STATE OF MAINE
DEPARTMENT OF TRANSPORTATION
16 STATE HOUSE STATION
AUGUSTA, MAINE 04333-0016

May 7, 2024
Subject: Perkins Bridge Replacement &
Lake Bridge Replacement
State WIN: 027098.00
Location: **Levant**
Amendment No. 1

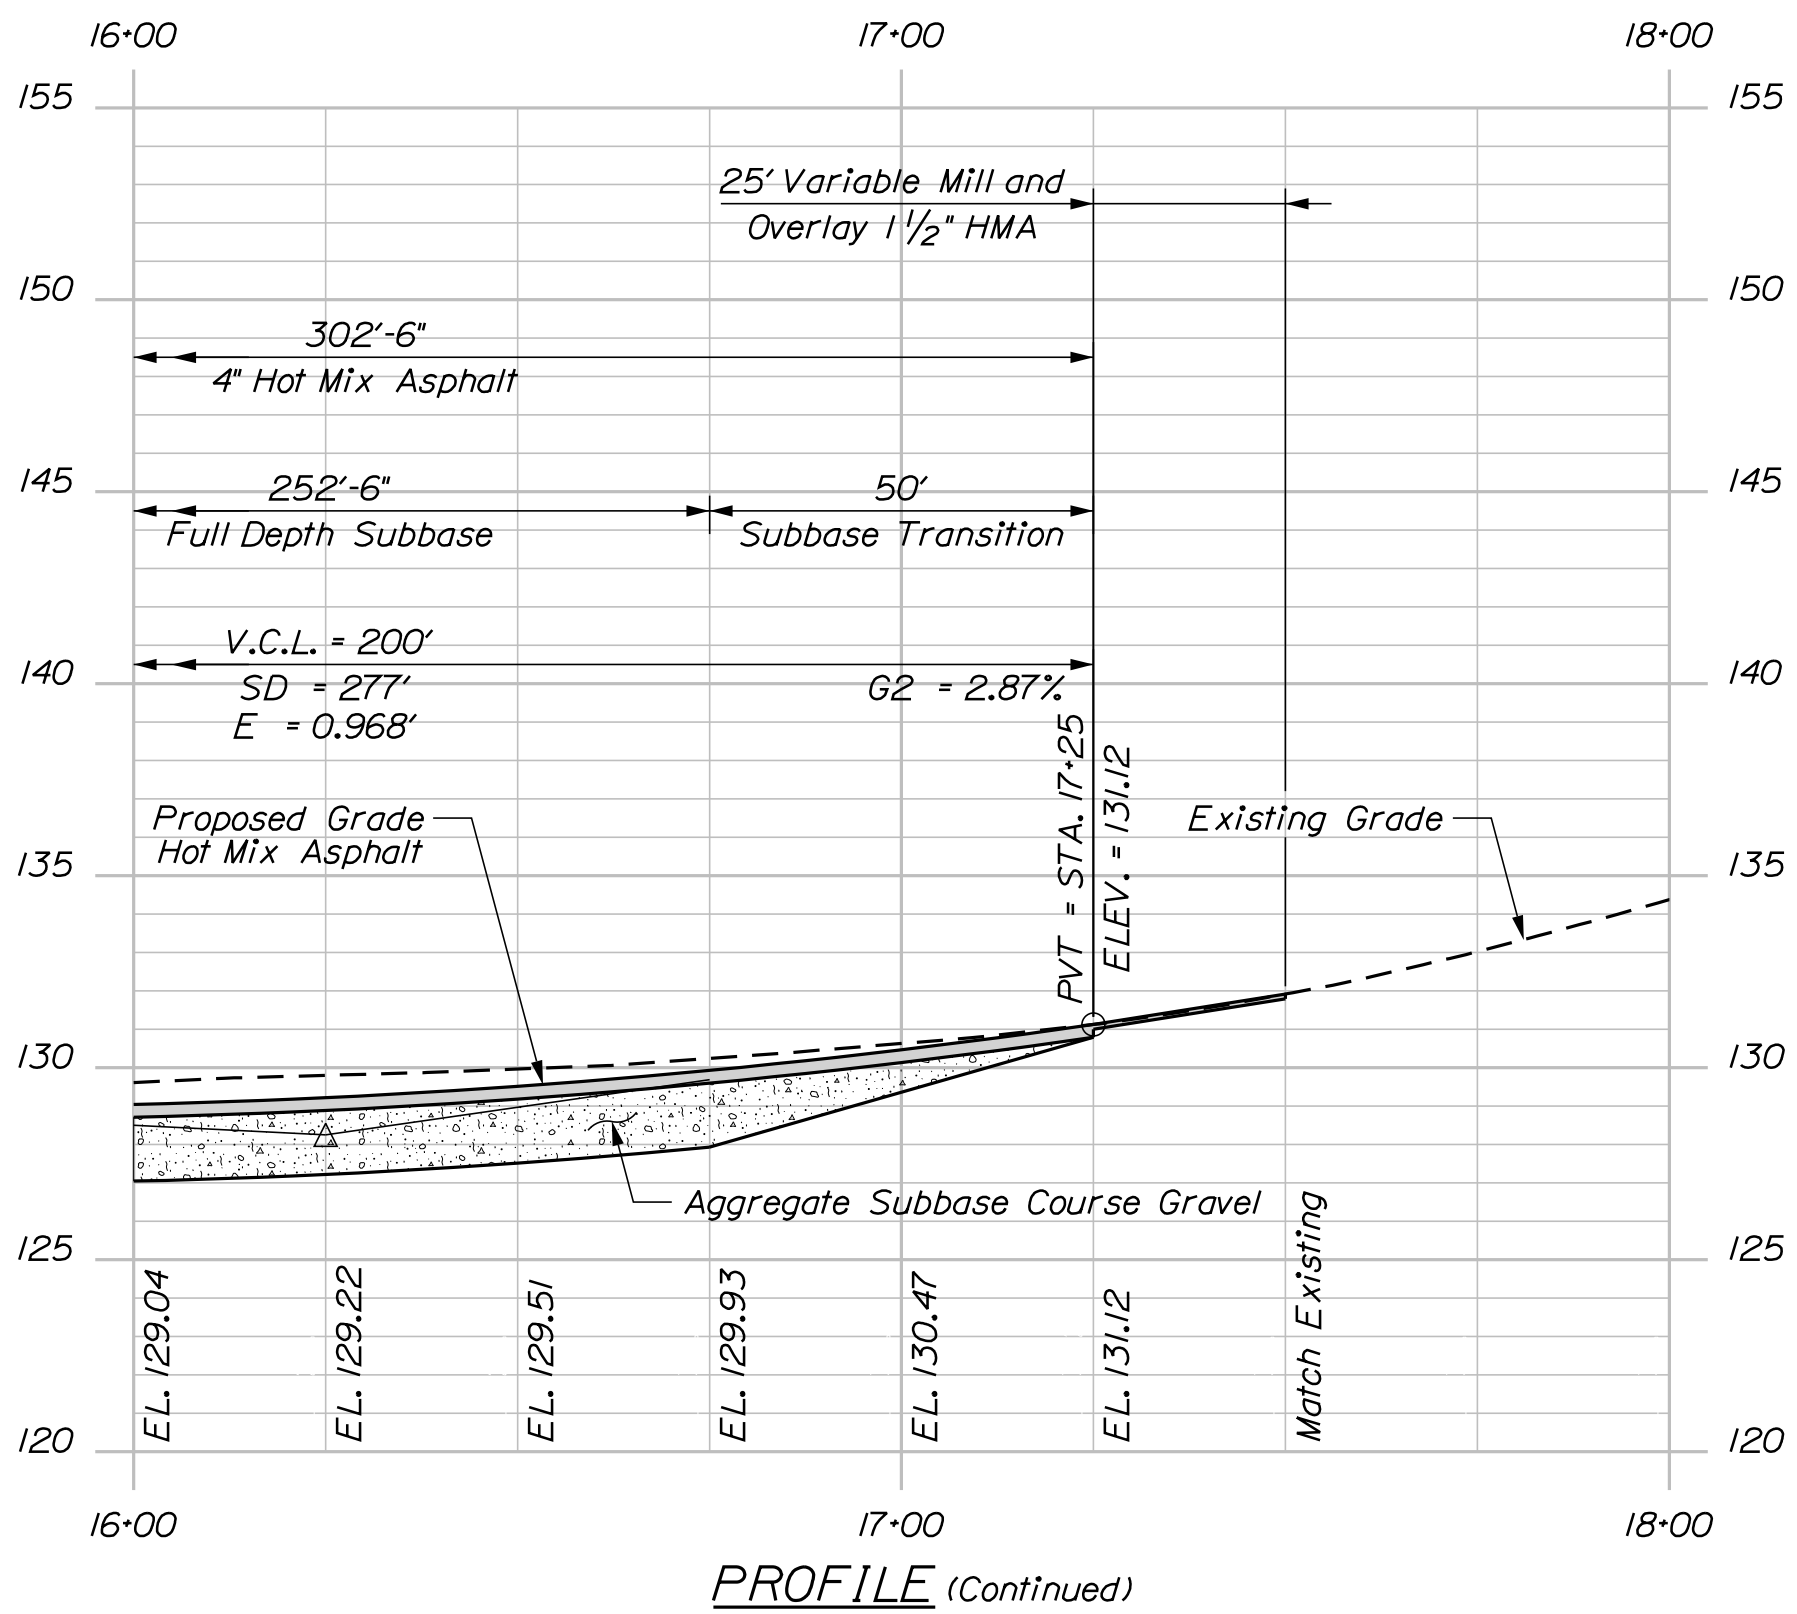
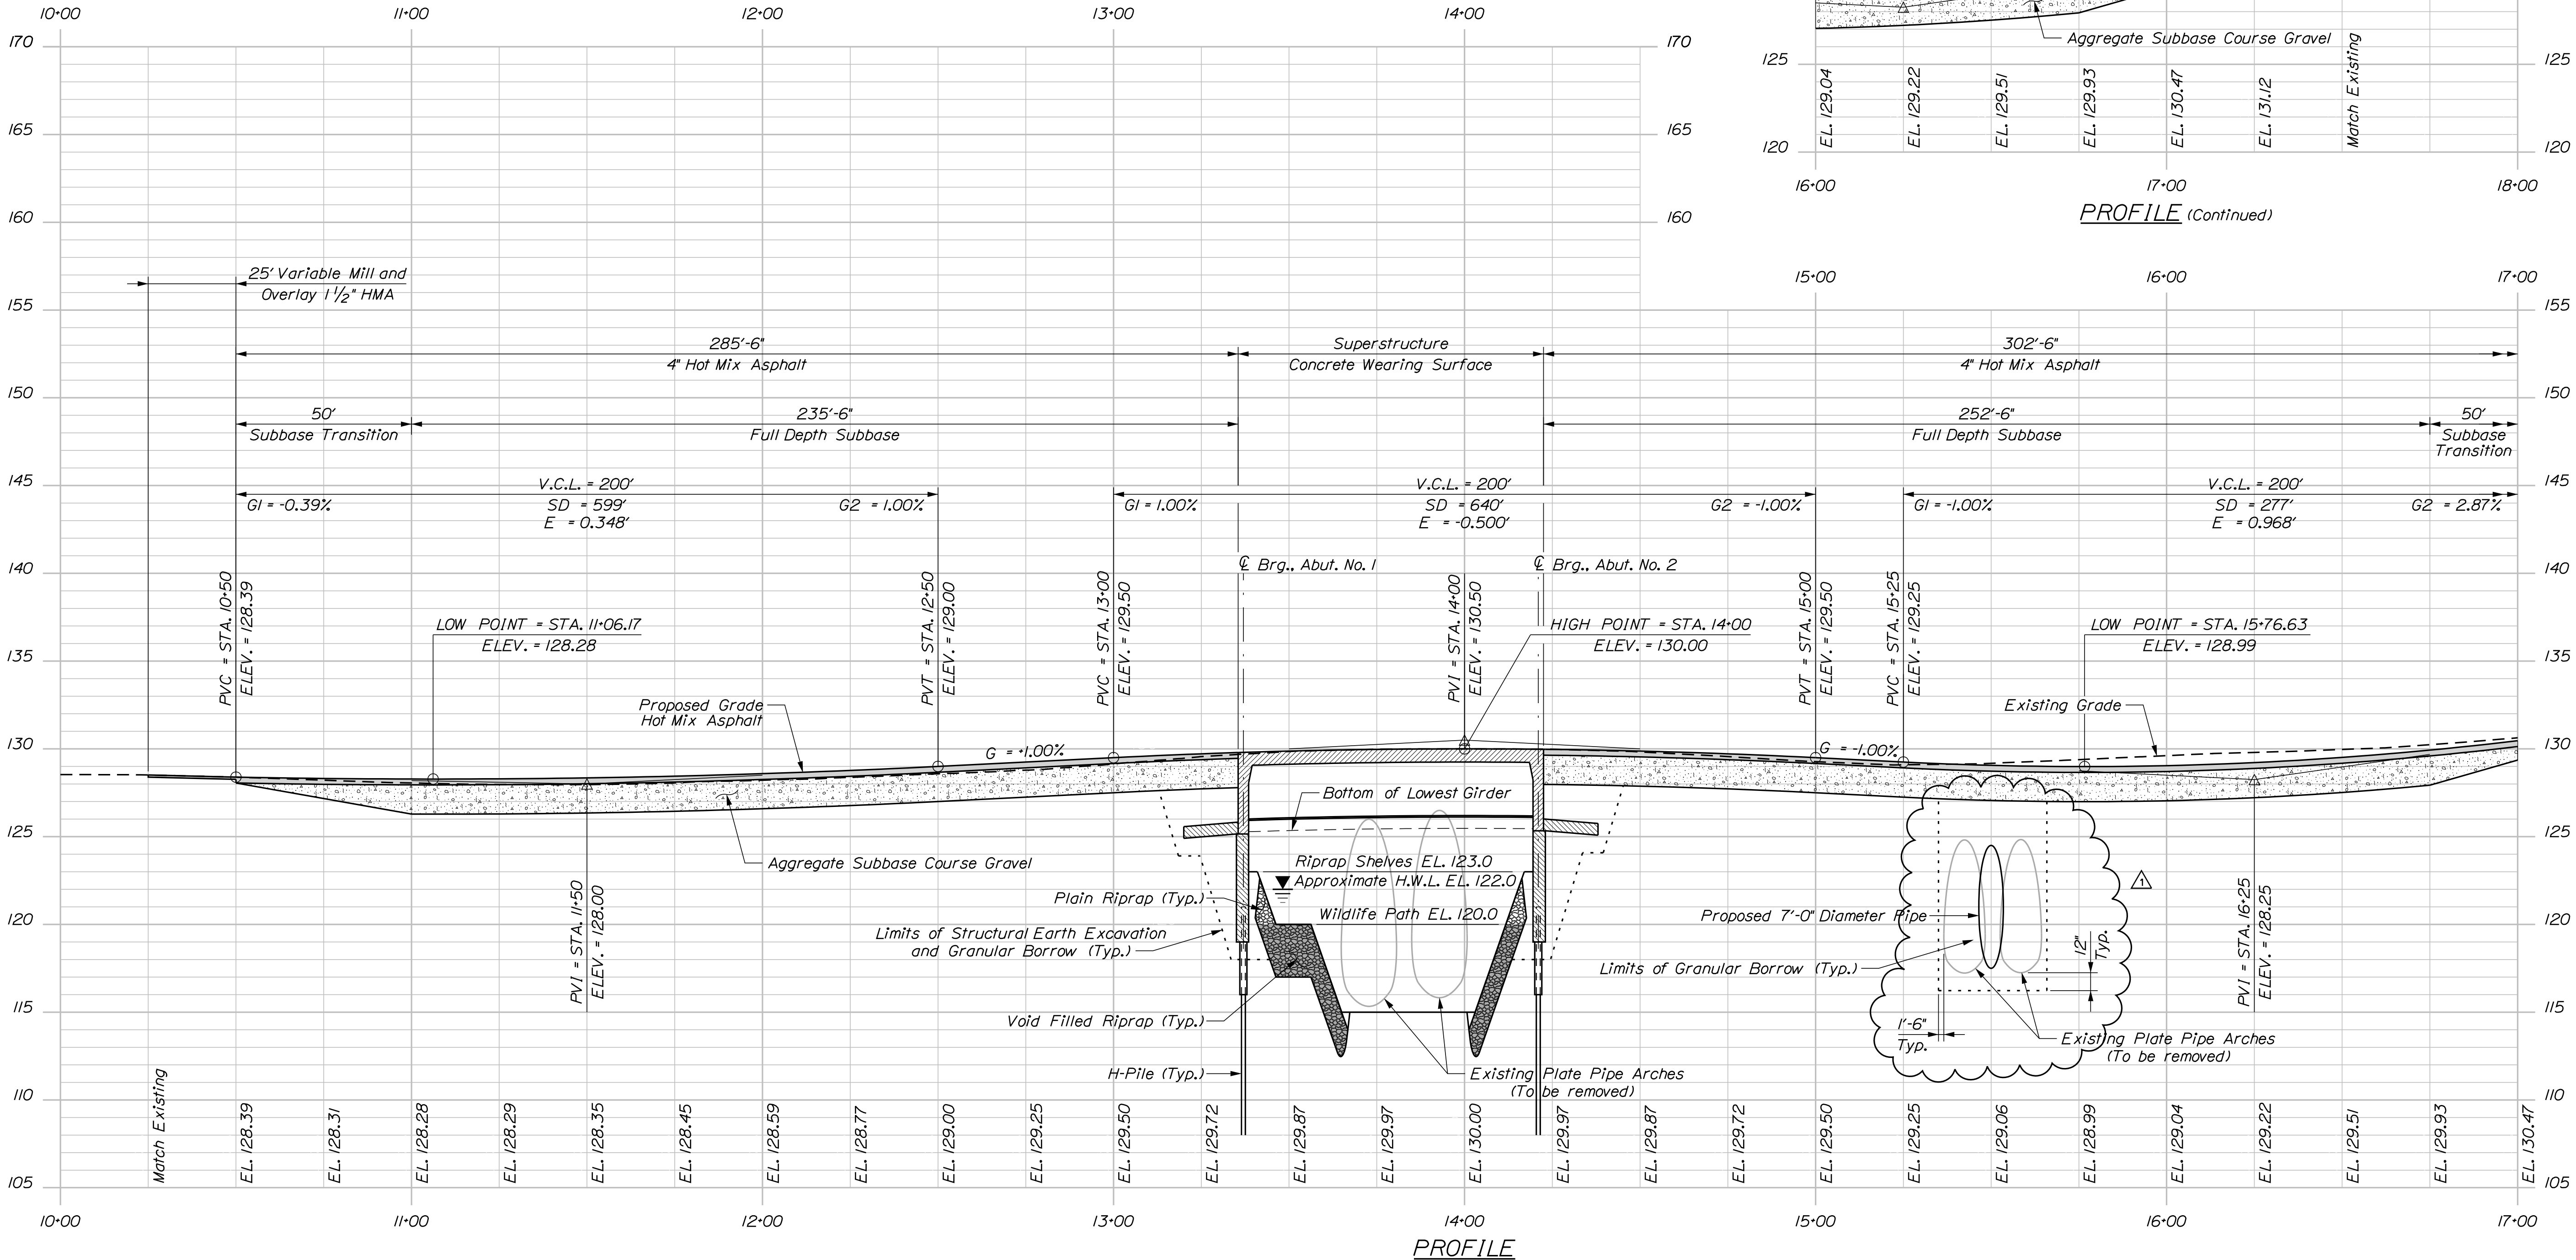
Remove Sheet 2 titled ESTIMATED QUANTITIES AND GENERAL CONSTRUCTION NOTES dated 3/20/2024 and **Replace** with the attached ESTIMATED QUANTITIES AND GENERAL CONSTRUCTION NOTES dated 5/6/2024

Question: Please confirm that excavation associated with the removal of the 2 existing pipes located at station 15+50 will be paid for as common excavation as stated in note 26 on page 2.

Response: Yes, the excavation associated with the removal of the pipes located at 15+50 will be paid for as common excavation as detailed on the revised Sheet 4 of 30. Note 26 on Sheet 2 of 30 has been revised.

26. Removal of the existing pipes and any excavation required outside of the Limits of Structural Earth Excavation and Granular Borrow will be the amount actually excavated, provided the maximum allowable horizontal dimensions do not exceed those bounded by vertical surfaces 18 inches outside the base or extreme limits of the structure and shall be paid for under Common Excavation.
